RM03-00001 CODE: D DD: A

DEC-O-LOG

Field Change Order Index

FIGURE 1

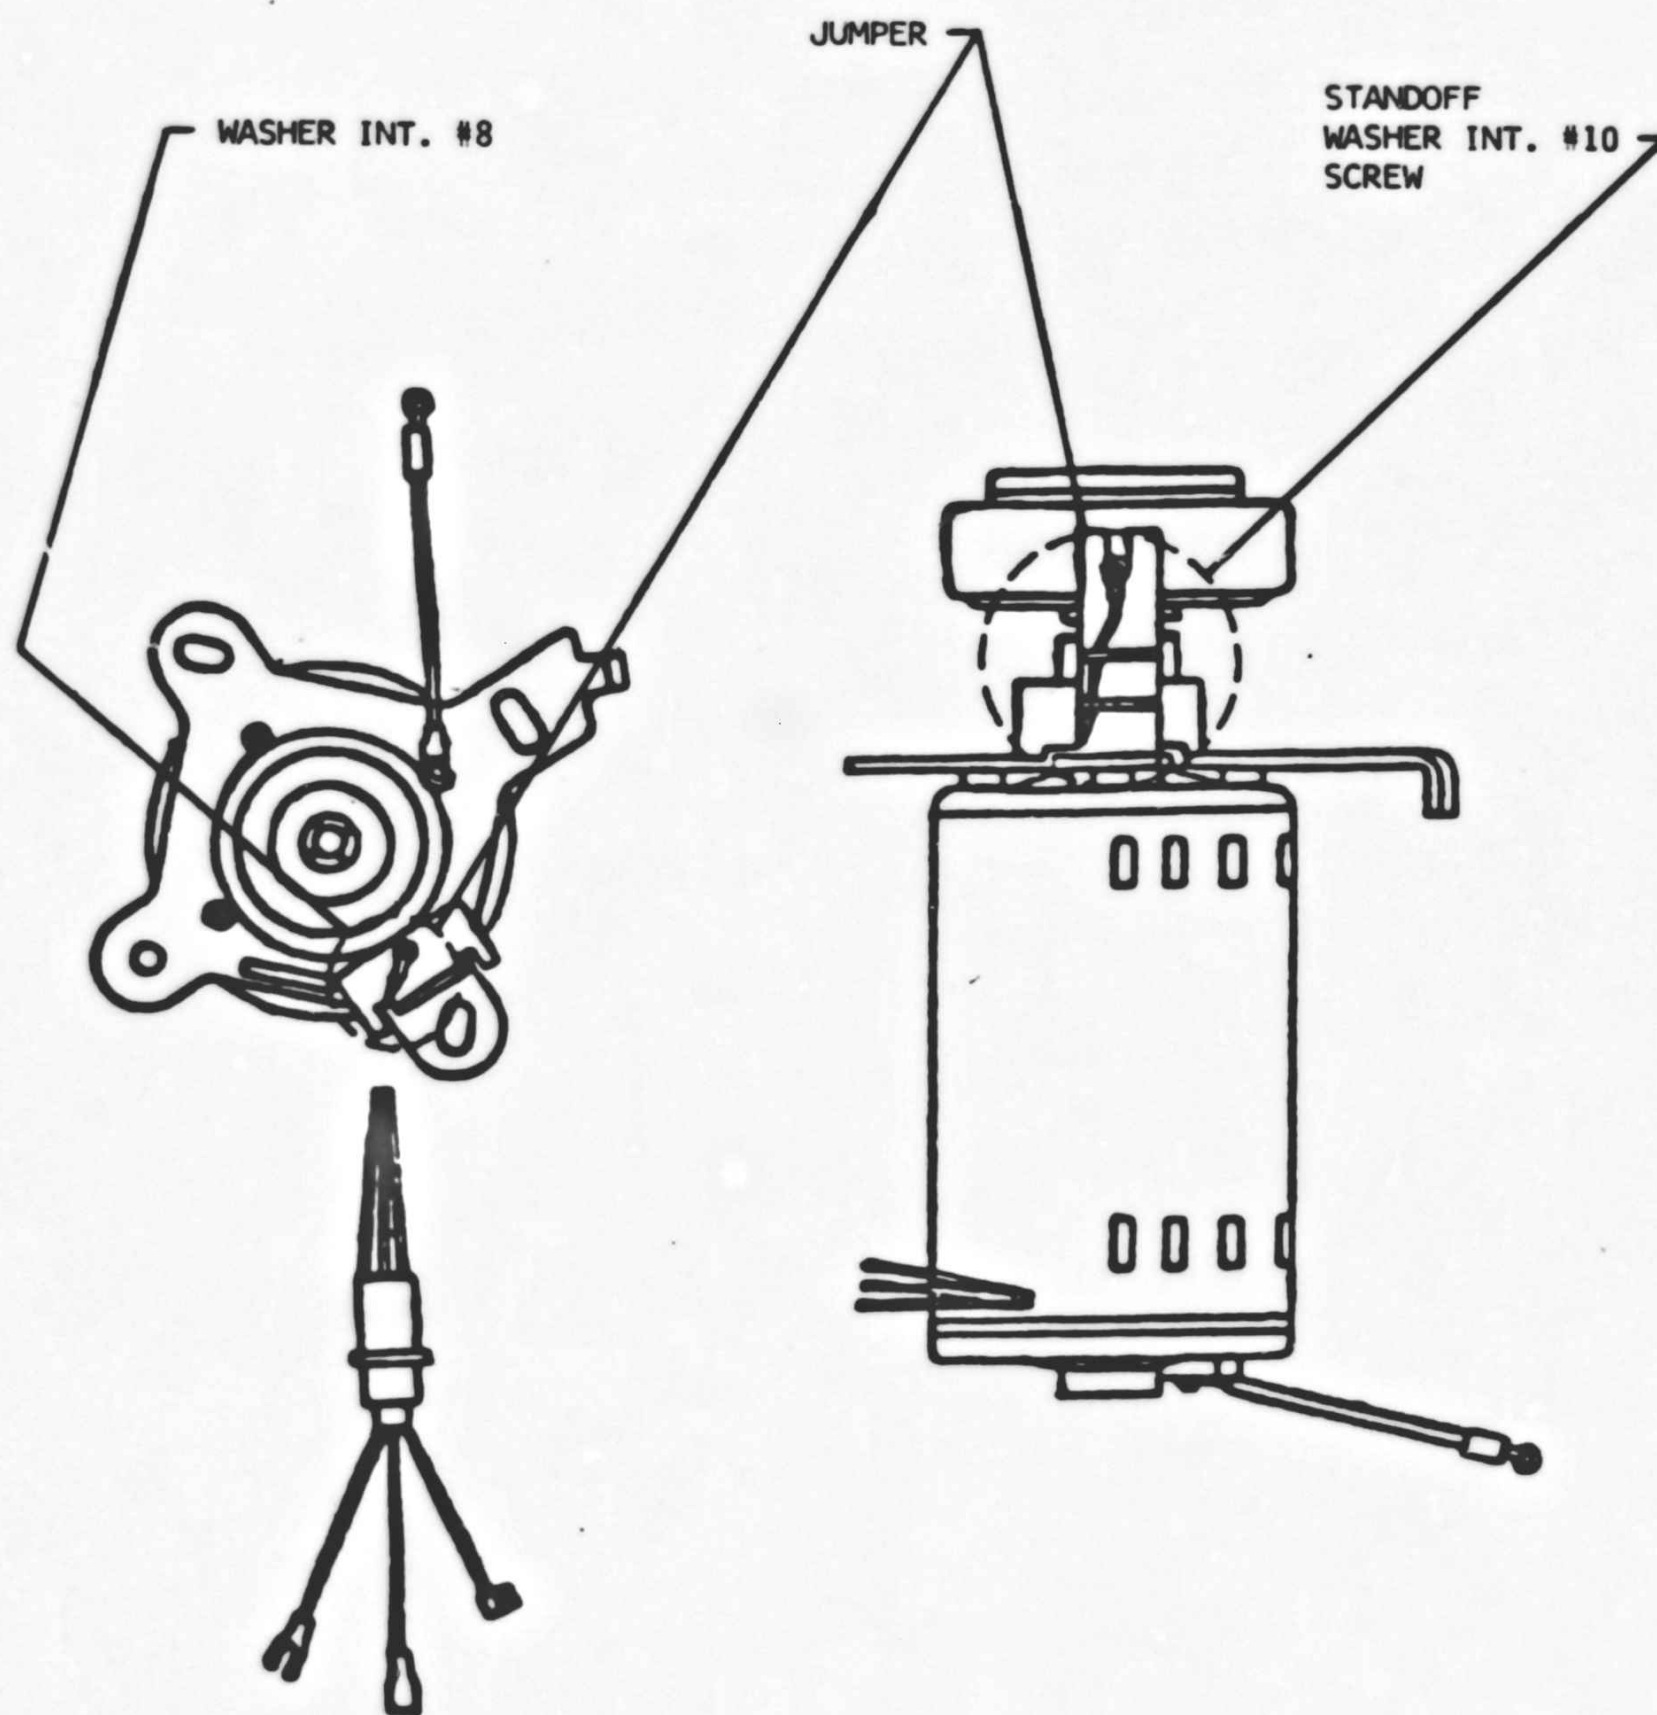
CORRECTION: Add grounding to brake assembly.

- 6- REMOVE TWO (2) SCREWS IN PACK WELL AND RAISE TOP DECK TO MAINTENANCE POSITION.
- 7- LOCK MAINTENANCE BRACKET IN PLACE WITH THUMB SCREW .
- 8- INSTALL ONE END OF GROUND JUMPER (CDC 77579946) ON DRIVE MOTOR MOUNTING PLATE USING EXISTING SCREW AND WASHER INT. #8 (CDC 10126104). (FIGURE 1)

- 9- INSTALL OTHER END OF GROUND JUMPER ASSEMBLY ON BRAKE ASSEMBLY STANDOFF USING WASHER INT. #10 (CDC 10126105), STANDOFF (CDC 73078800), AND SCREW PAN HD. (CDC 10127361). (FIGURE 1)

Figure 2 Start Triac A3K5

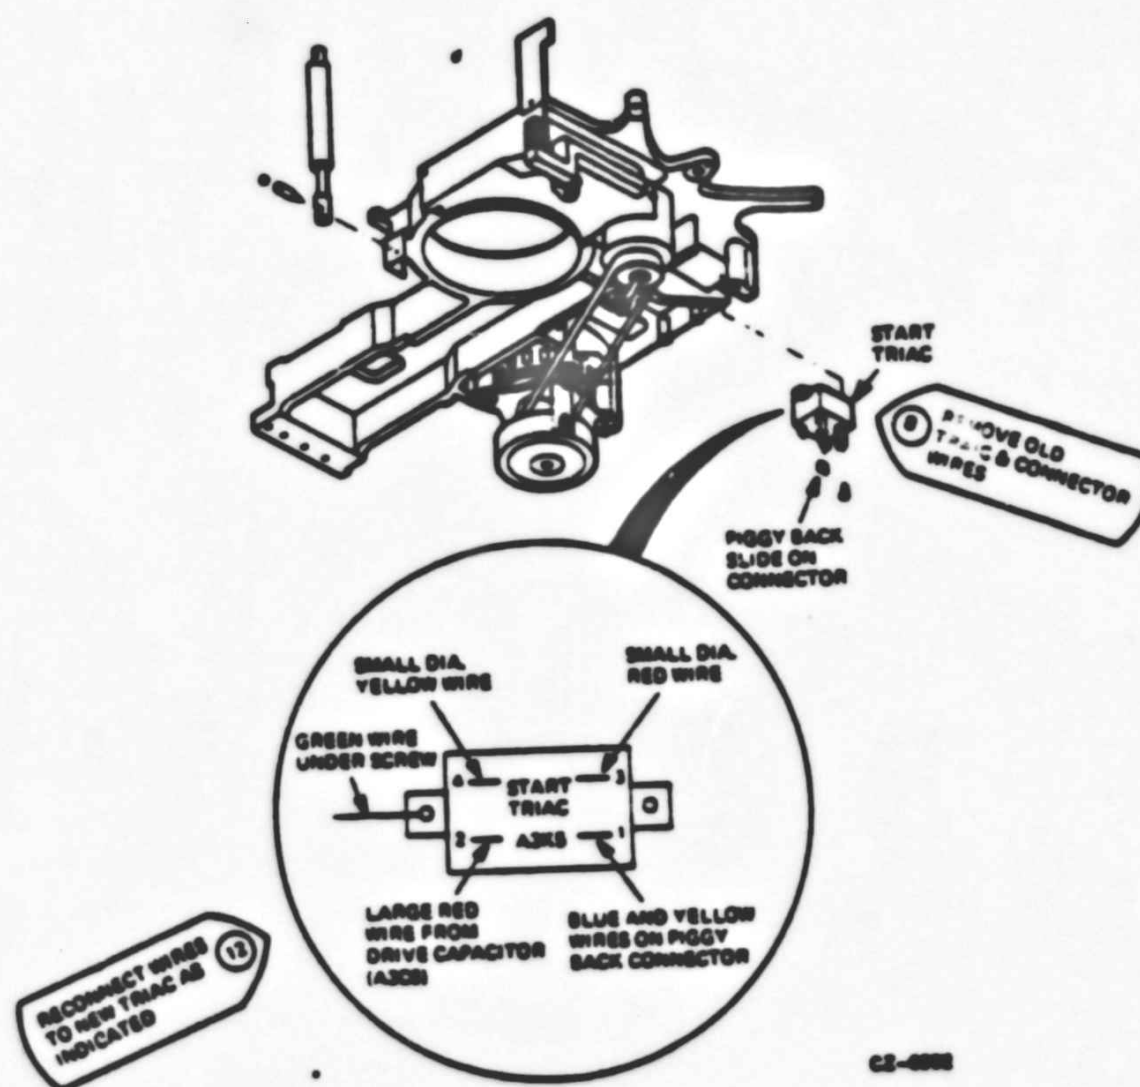
MAY 84 - PROBLEM: Possible start relay failure due to the peak inverse voltages in the excess of the device rating.
CORRECTION: Replace the 600 volt start relay (A3K5) with the 800 volt start relay per CDC NEC #J255.
IN-PLANT EFFECTIVITY: Aug 82
FIELD EFFECTIVITY: Retrofit all RM03 drives, series 42 and below when the Problem/Symptom is evident.
QUICK CHECK: CDC P/N 94378603 is stamped on the relay at location A3K5 in the RM03 drive.

9. Remove the two (2) screws that secure the triac in place.
10. Apply a light coat of dielectric grease to the base of the new triac.
11. Mount the new triac using the two (2) screws previously removed. Be sure to attach the green grounding wire to one of these screws.
12. Reconnect all wires to the triac terminals according to Figure 2.
13. Release the deck support bracket and lower the deck into the operating position.
14. Re-install the two (2) deck hold-down screws inside the pack shroud area.
15. Remove the rear hold-down spacer and install it in the keeper hole.
16. Restore the head actuator holding pin to its "storage" hole.
17. Replace the top cover onto the Drive.

FIGURE 2

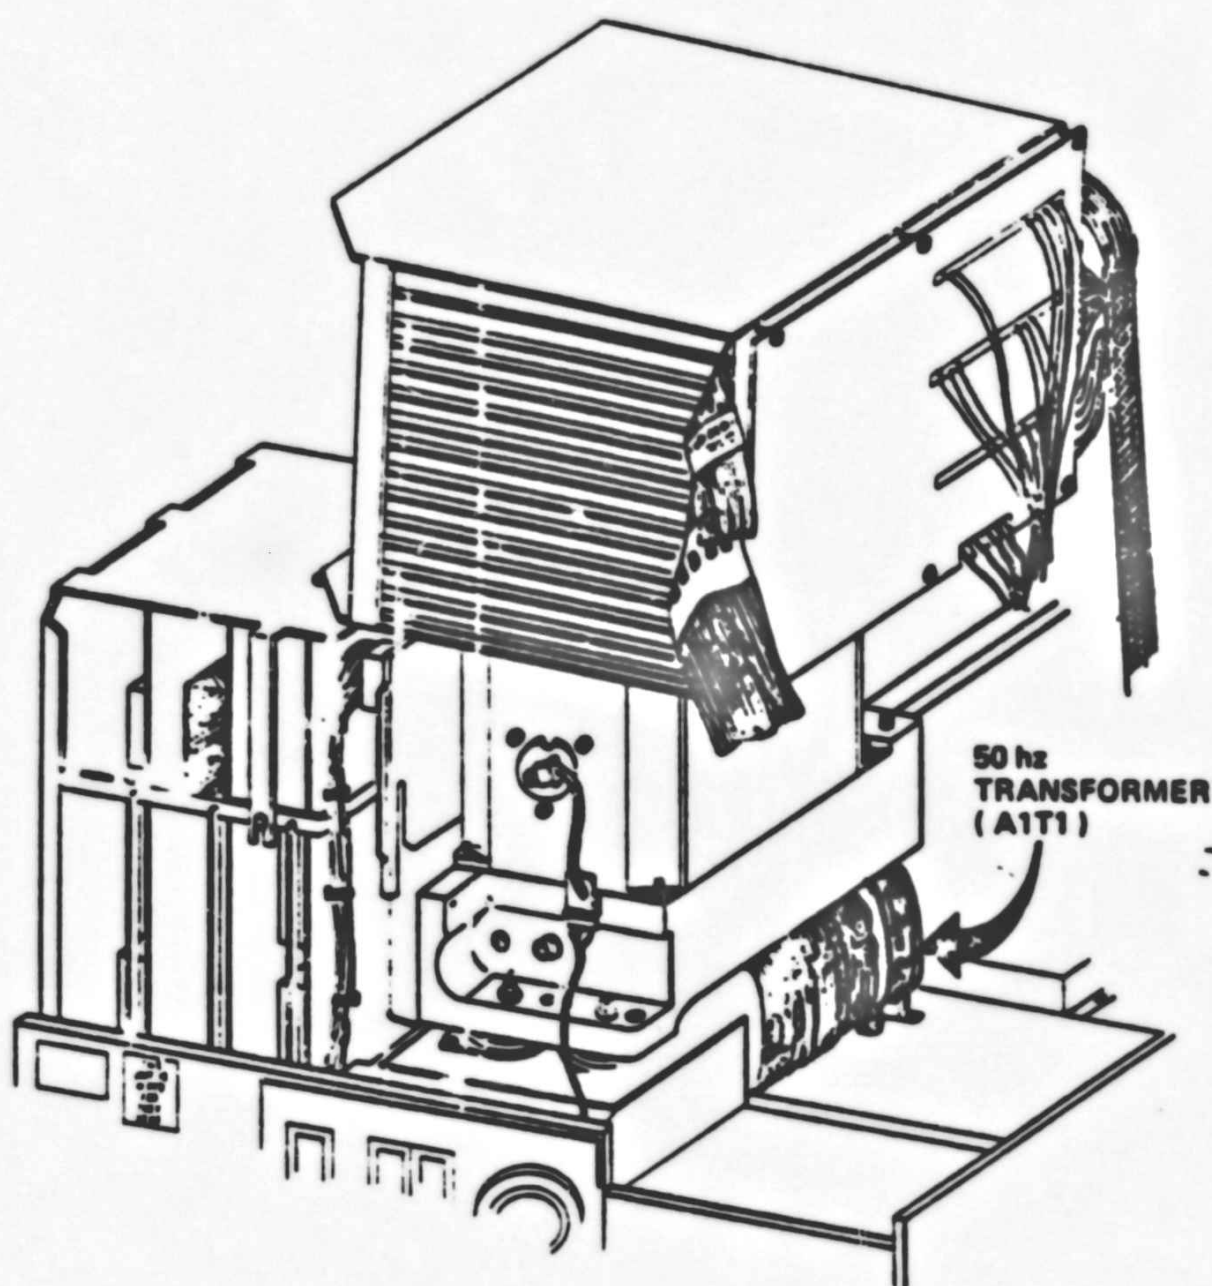
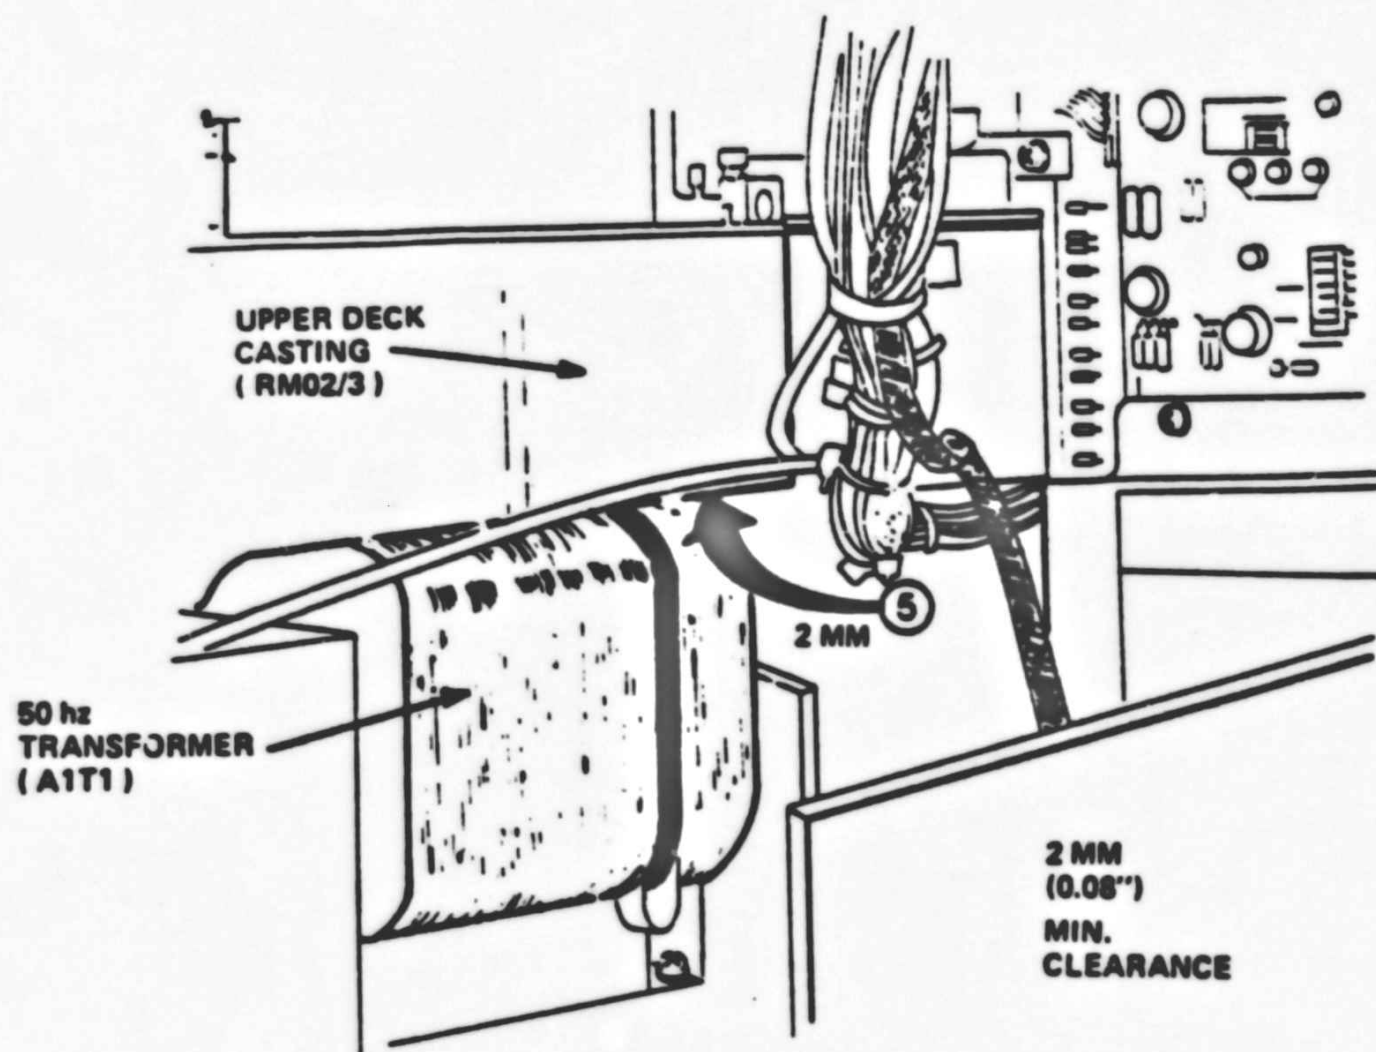
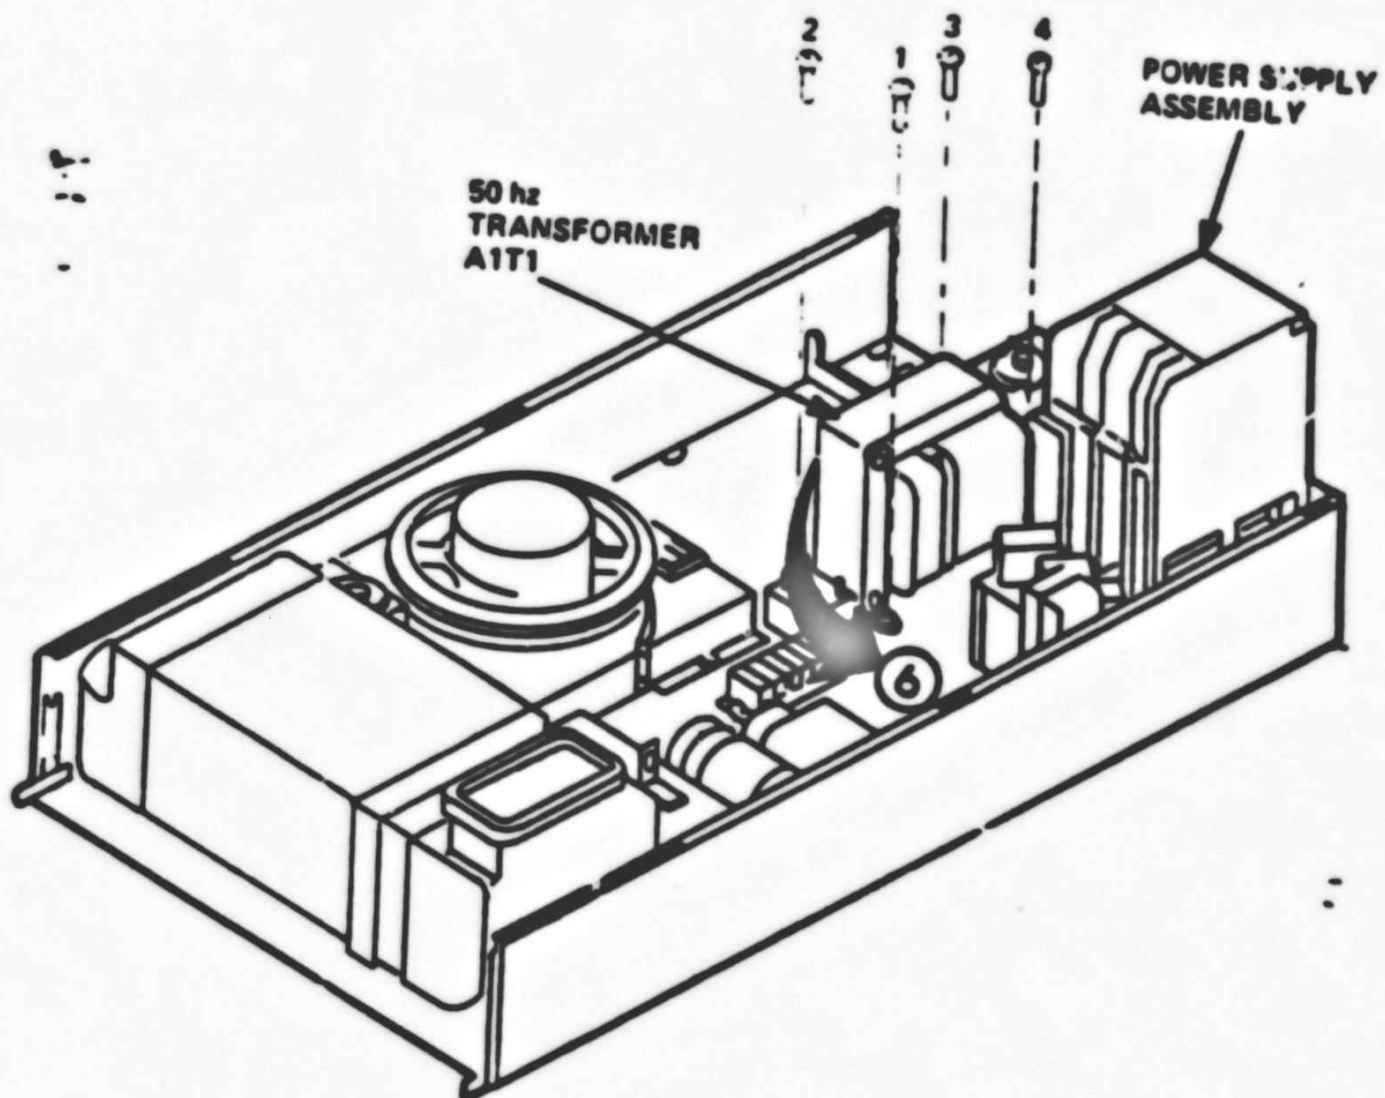
AUG 85 - IN-PLANT EFFECTIVITY: MAY 85
PROBLEM: Transformer (A1T1) may come in contact with the upper deck plate assembly (when raised or lowered); resulting in damage to the transformer winding insulation and/or shorting of the transformer windings to the chassis.
FIELD EFFECTIVITY: Inspect and retrofit (if necessary) all RM03 50 Hertz Drives. All 29-22908 50 Hertz Replacement Transformers require incorporation of this FCO when they are installed.
QUICK CHECK: Drive Revision is "T" or standoffs on Power Amplifier Assembly.

9. With the deck in its lowered position, check to be sure that there is a minimum clearance of 2mm (.08 inches), between both the left and right side of the AC power transformer winding insulation and any part of the upper deck plate assembly. The critical areas of clearance are noted by the arrows labeled with no. 5 in FIGURE 3. A flashlight and feeler gauge may be required. The side of the transformer closest to the power supply assembly, see FIGURE 4, can be observed by looking through the hole in the rear of the positioner (ARROW 3, FIGURE 1) and applying sufficient light (with a flashlight) as shown by ARROW 4 in FIGURE 1. Assure that there are no pinched wire harnesses and no chance of damage due to contact between the transformer assembly and the upper deck chassis or other surrounding components.

5. Slightly loosen the transformer mounting screws #1, #2, #3, and #4 (shown in FIGURE 4).

- E. Remove the two screws that secure the power amplifier to the deck casting. An offset phillips screwdriver will be needed.
6. Carefully move the transformer to the left or right to obtain the required clearance of 2mm (.08 inches), on both sides of the transformer. This would be in a direction from left-to-right when viewing the transformer from the front of the drive (See ARROW 6 in FIGURE 4).
